SYDNEY WESTERN CITY PLANNING PANEL BRIEFING 2019WCI003 – Liverpool – DA922/2018

This letter has been prepared on behalf of Frasers Property Australia regarding the above application to provide additional information in response to the comments raised by the Panel as a result of their briefing on 11 February 2019.

Figure 2 Dwelling 12123 and 12124 separation plan

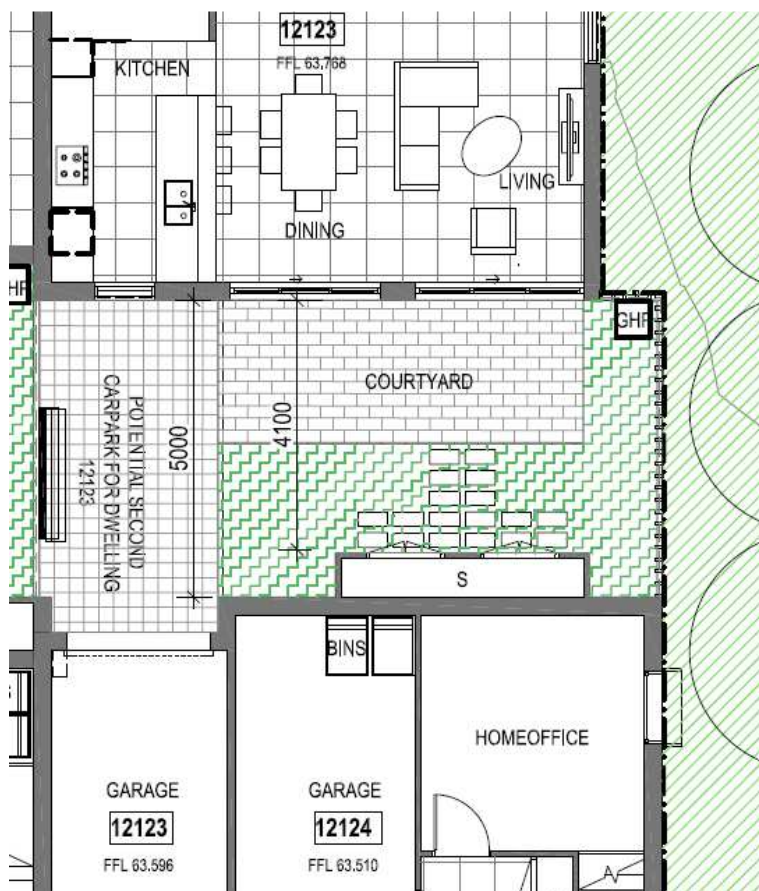
The Panel sees the 4-metre setback between the terraces and corresponding rear studios as important, and questions whether it is appropriate to reduce that dimension to incorporate the ground level "offices" within the studios.

It is understood that this comment is in reference to the separation between terrace dwelling 12123 and studio dwelling 12124. This is the only dwelling with any variation to rear separation, being a specific design issue related to them being corner dwellings.

Attached is an amended Architectural plan which annotates the separation distance between dwellings (see **Figure 2**). The plan shows that the separation between the terrace window and wall of the studio dwelling is 5m; greater than the minimum, required by the Design Guidelines.

Figure 5 Amended Storage Plan

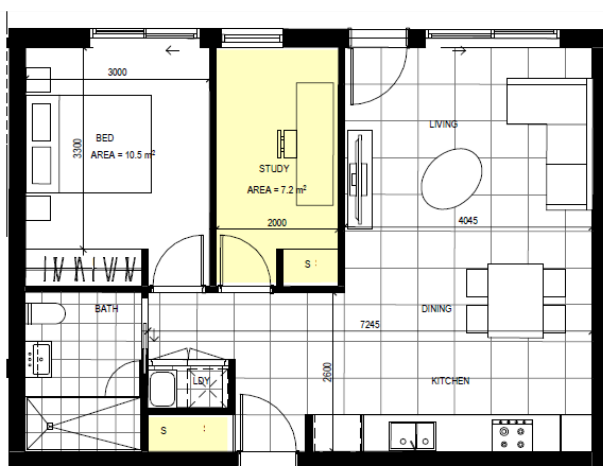
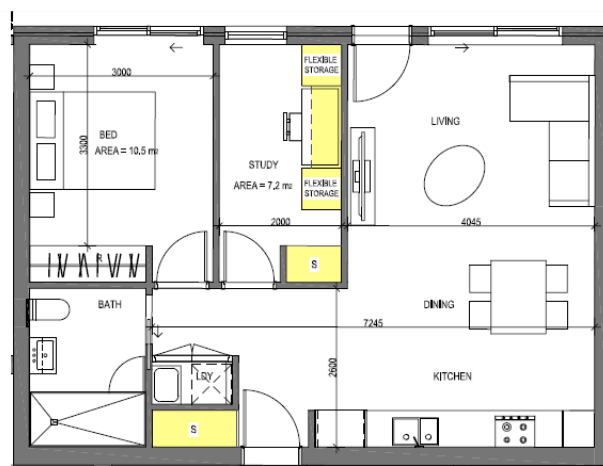
The Panel is concerned that the “storage” areas within the units seem to have been designed to serve alternatively as an extra bedroom or an office, and seeks further information as to how that aspect of the development is to be regulated or redesigned.

We understand this is in reference to the Type I – one bedroom + study. The typology plan had previously shown the study as a flexible space that highlighted the whole room as storage. The intent of this was to show that the study room and its final configuration was flexible as to the location of storage (i.e. up to the purchaser) (see **Figure 4**).

The typology plan has been updated (see **Appendix D**) to show the anticipated layout of the office and how a flexible storage shelf and furniture may be incorporated. The dwelling provides 6m³ storage in accordance with the Design Guidelines (see **Figure 5**).

It is noted the room is not labelled for any use other than a study. It does not meet the dimensional requirements for a bedroom (bedroom requires 3m x 3m and subject room is 2m x 3m). Frasers are unaware of a regulation open to Council other than a condition of consent to regulate the room as a study. Such a condition would be very difficult to enforce once the dwelling has been sold.

Figure 7 Dwelling 12125 as amended

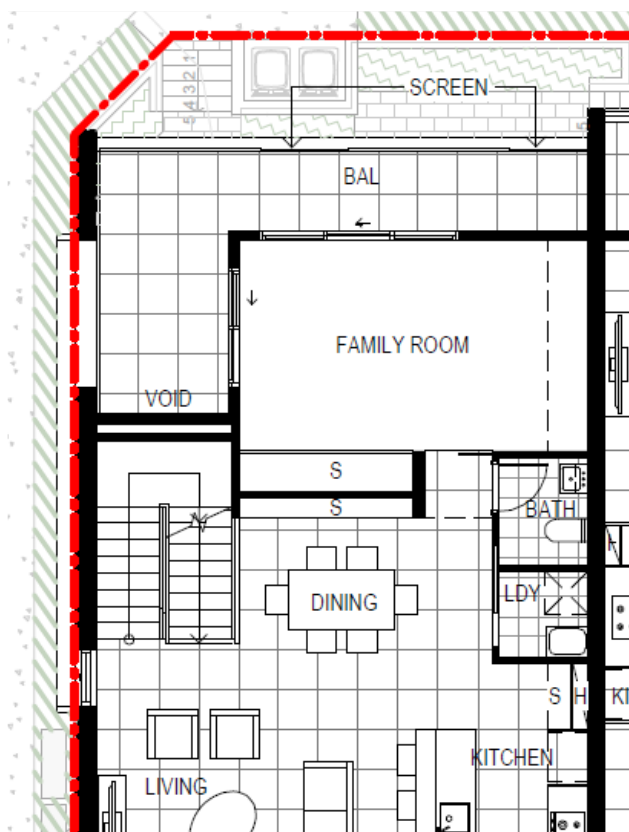
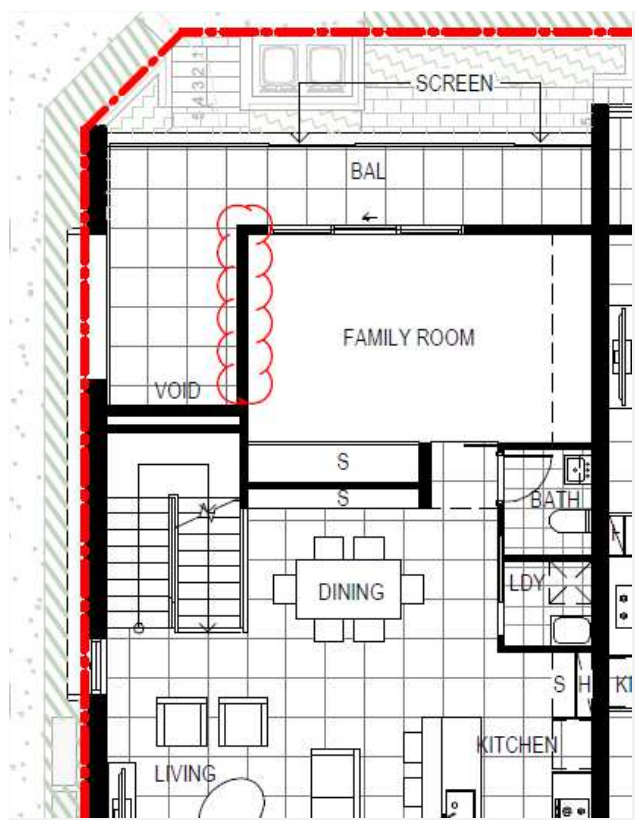
The Panel was interested that BASIX compliance was to be achieved through the deletion of windows, and asked whether the loss of amenity offered by those windows preserved good design

Frasers has amended the design for the Type K - 4-bedroom typology where the home faces the end of a block. The change is proposed not for Basix compliance but to facilitate the internal use of the home and how it is to be fit out. The change is limited to Block D-South and dwellings 12025 and 12154. Amended Plans are provided at **Appendix A** and shown at **Figure 6** and **Figure 7**.

Figure 9 Waste Collection diagram

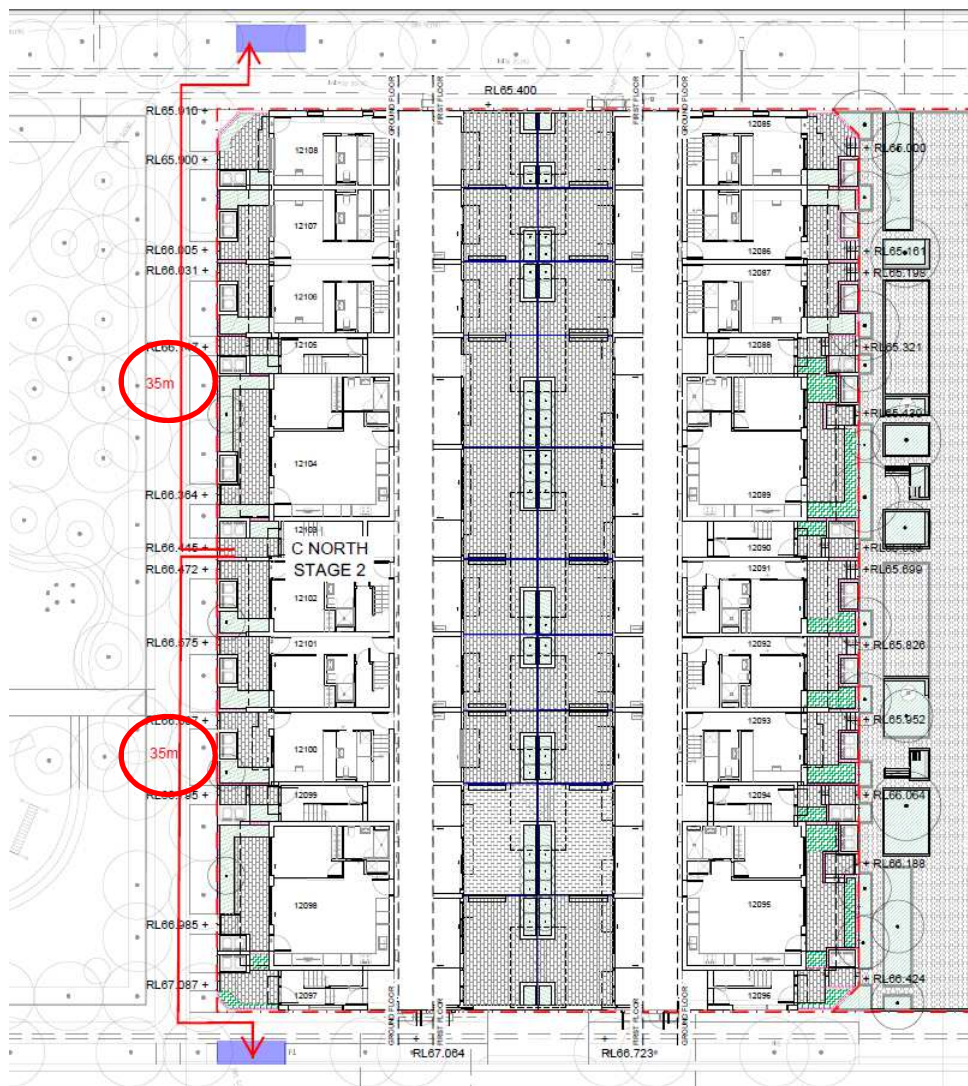
Distances from units to the waste collection areas should be taken into account.

Of the 128 dwellings in the Stage 2 application, those 12 homes that have a direct frontage to a park, rather than to a road or mews, are required to take their bins to a dedicated collection point at the closest road. The distance for a resident to the collection point is 35 metres or less. 35 metres is the maximum distance and most residents are located closer to the collection point (see **Appendix G**).

The collection arrangement relevant to this application is shown in the **Figure 9** below.
